**COUNTY OF SAN MATEO
PLANNING AND BUILDING DEPARTMENT**

SUBJECT: EXECUTIVE SUMMARY: Consideration of a Coastal Development Permit, Design Review, and Certificate of Compliance Type B to allow construction of a new single-family residence and a detached garage on an undeveloped parcel, located on San Carlos Avenue in the unincorporated El Granada area of San Mateo County. This project is appealable to the California Coastal Commission.

County File Number: PLN 2017-00098 (Ridgway)

FRONT ELEVATION
SCALE: 1/4" = 1'-0"

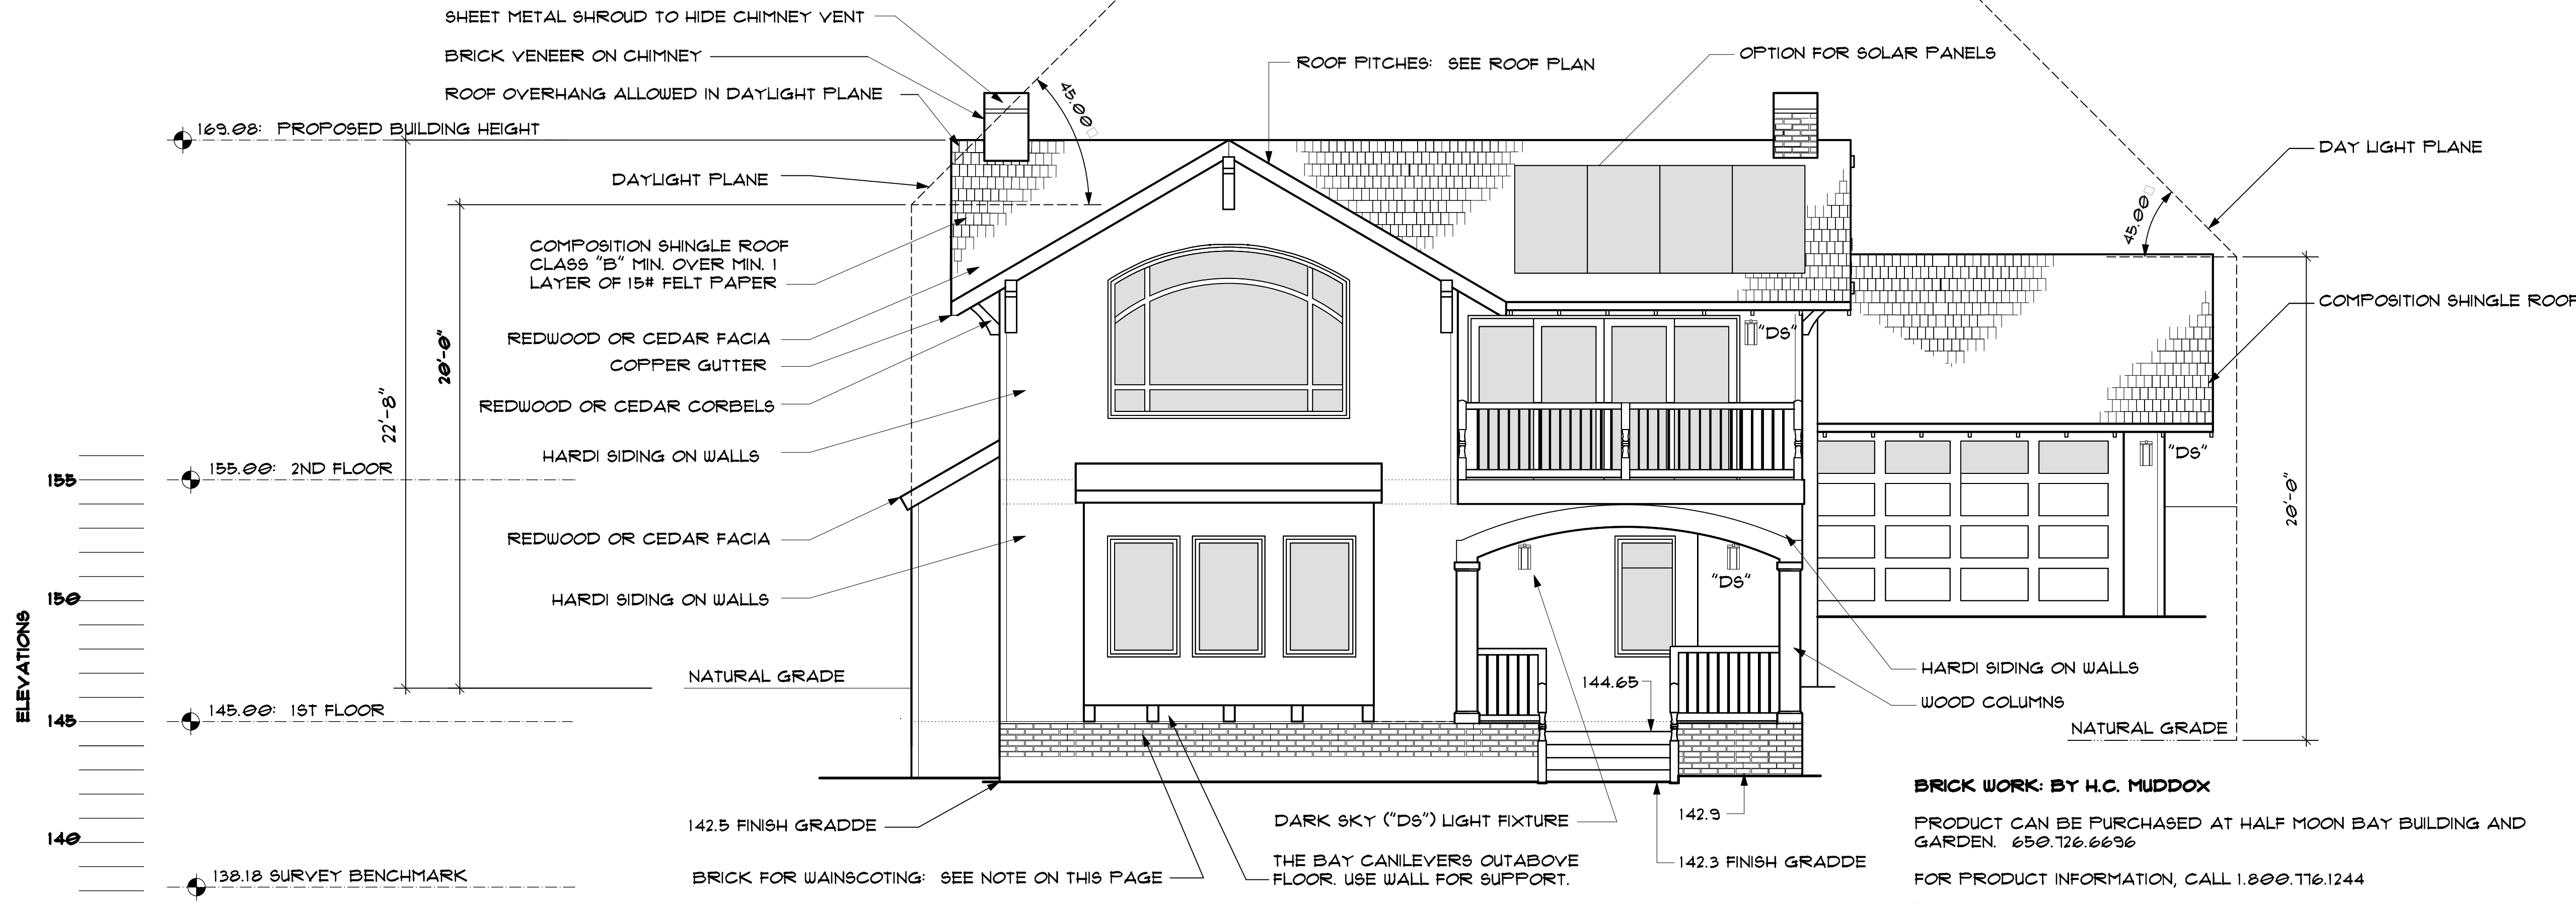
7. The applicant shall indicate the following on plans submitted for a building permit, as stipulated by the Coastside Design Review Committee.
 - a. Continue the brick fascia around the front elevation to both the left and right elevations, extending back on the right elevation to the end of the porch and extending back on the left elevation to the first inside corner.

- d. Include details for the drywell and concrete swale for the garage.
 - e. Lighting:
 - (1) At the front elevation at the front porch, replace the two exterior Dark Sky light fixtures with two recessed can lights.

LANDSCAPING PLAN

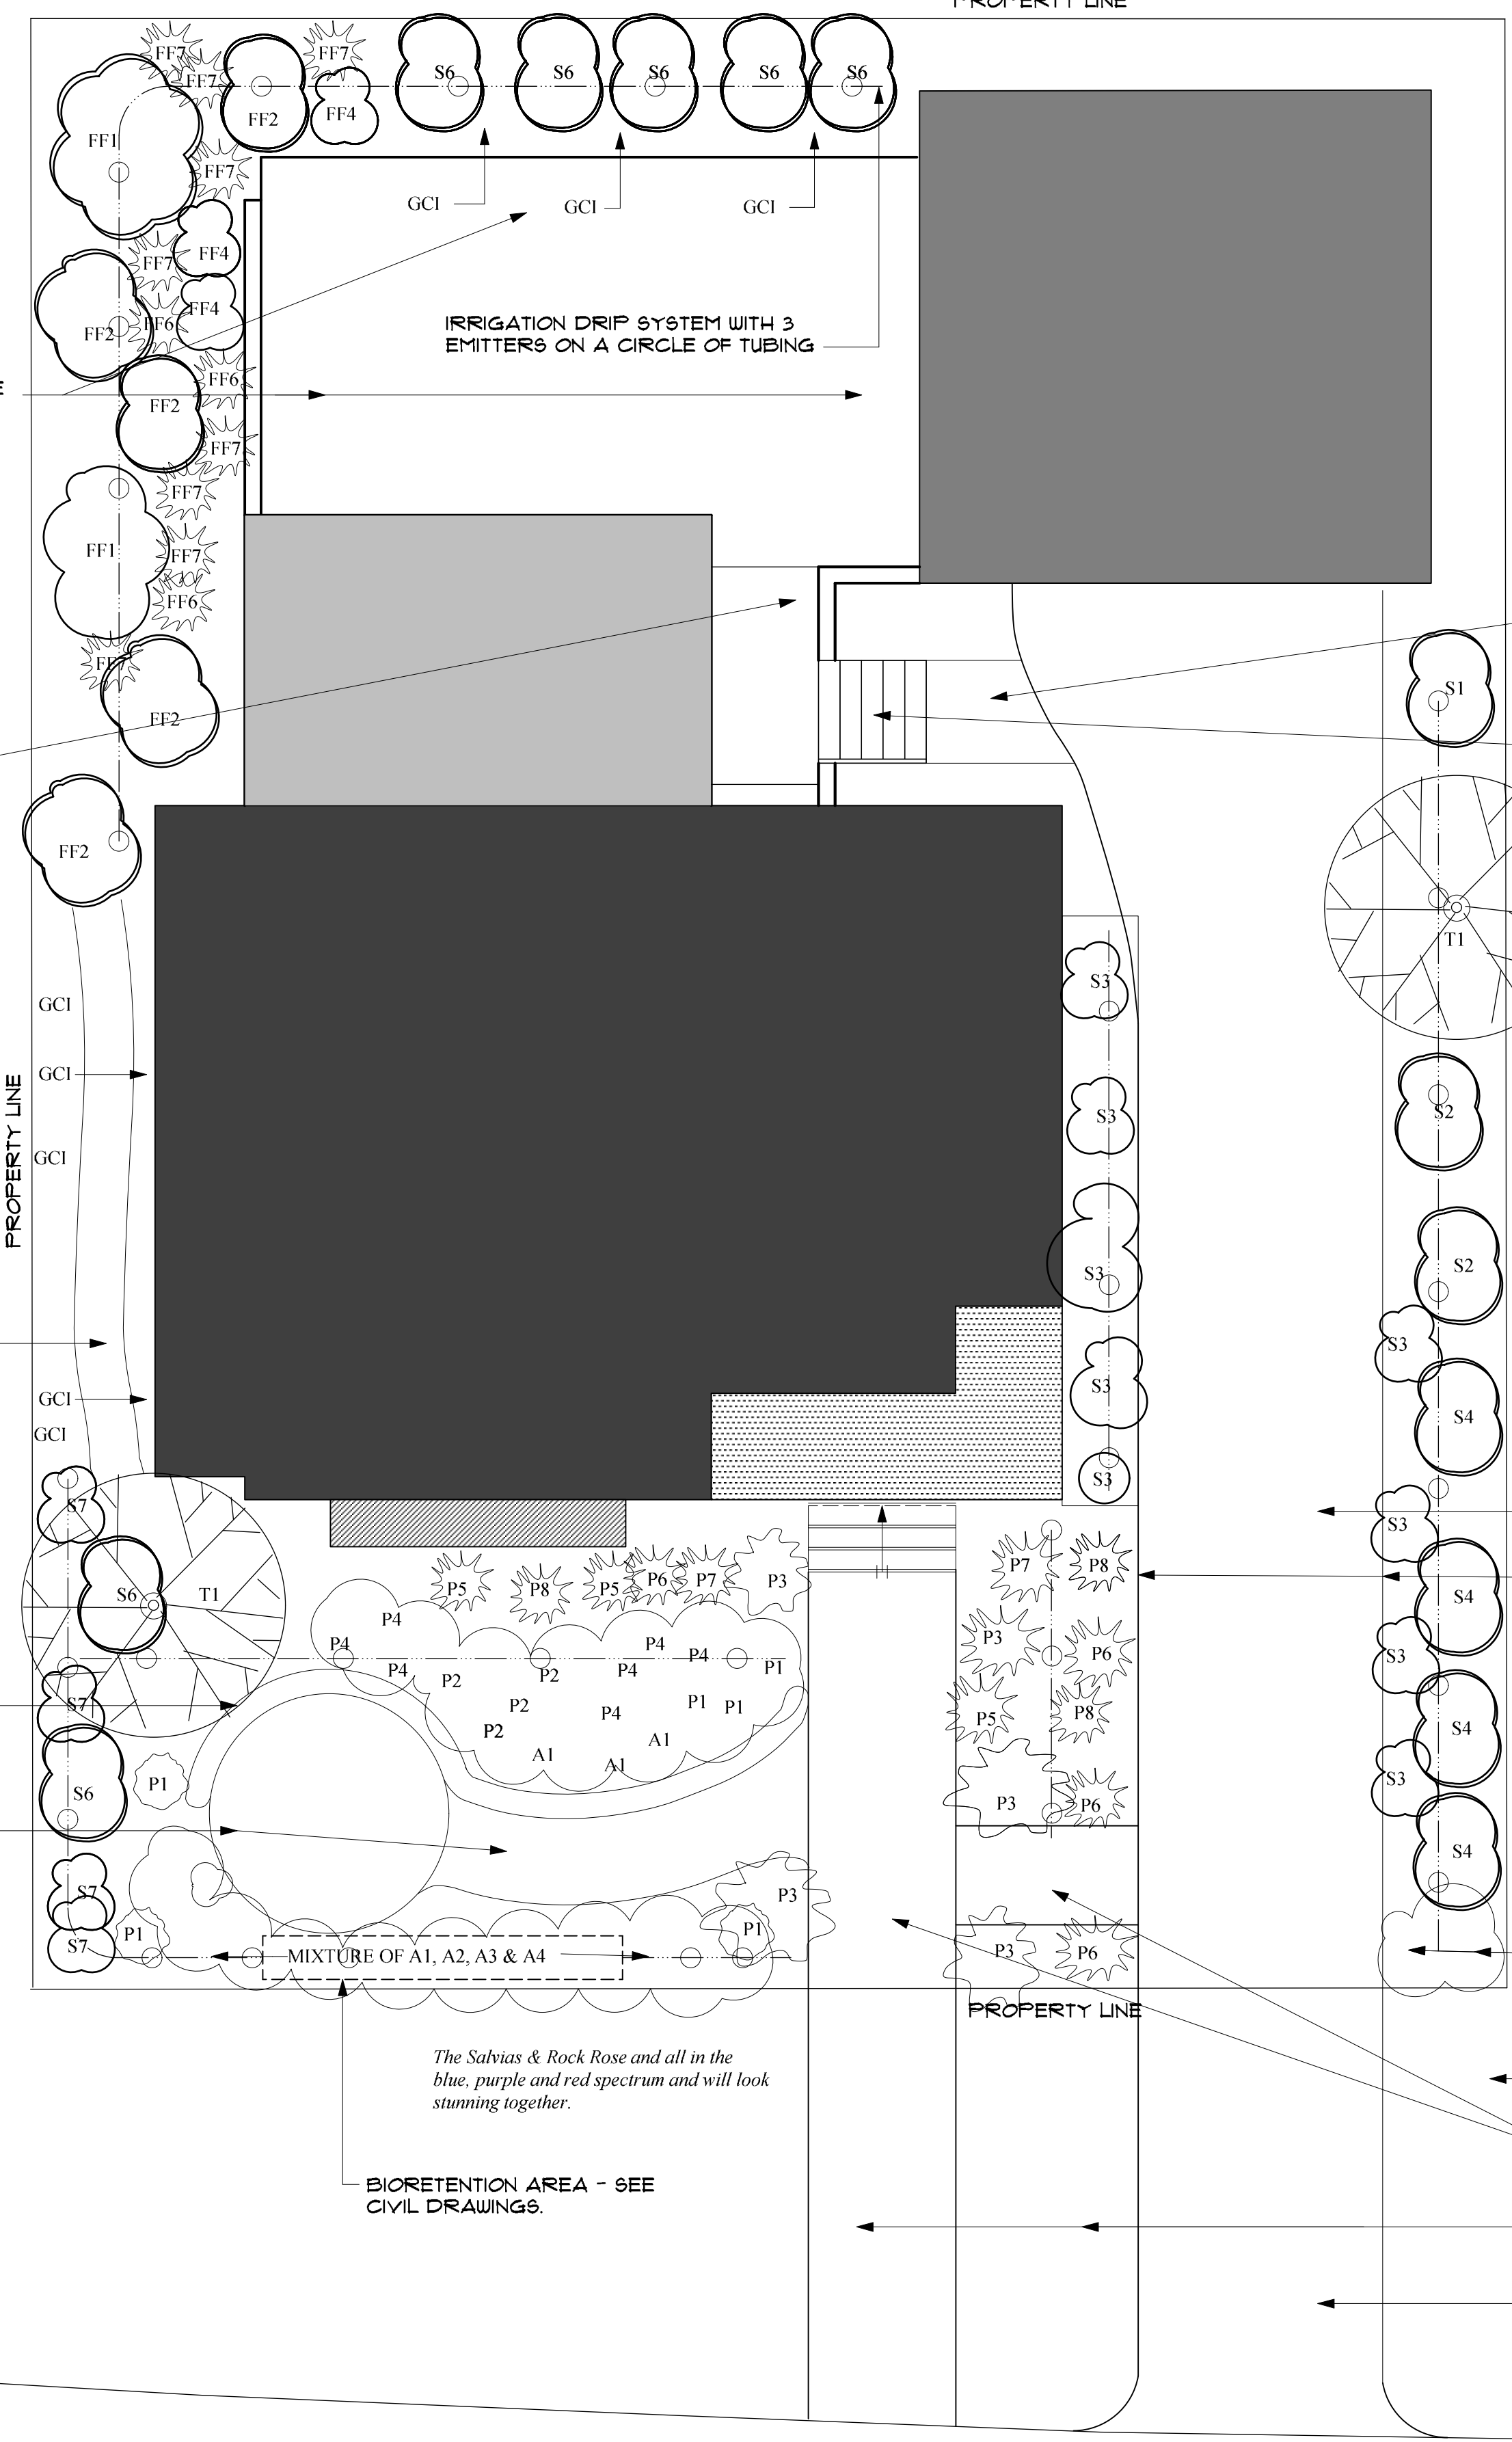
- h. Install a Redwood good-neighbor fence with a maximum 6-ft. height at the right and rear property lines.
 - i. Use a taller shrub for the planter adjacent to the right side of the house.
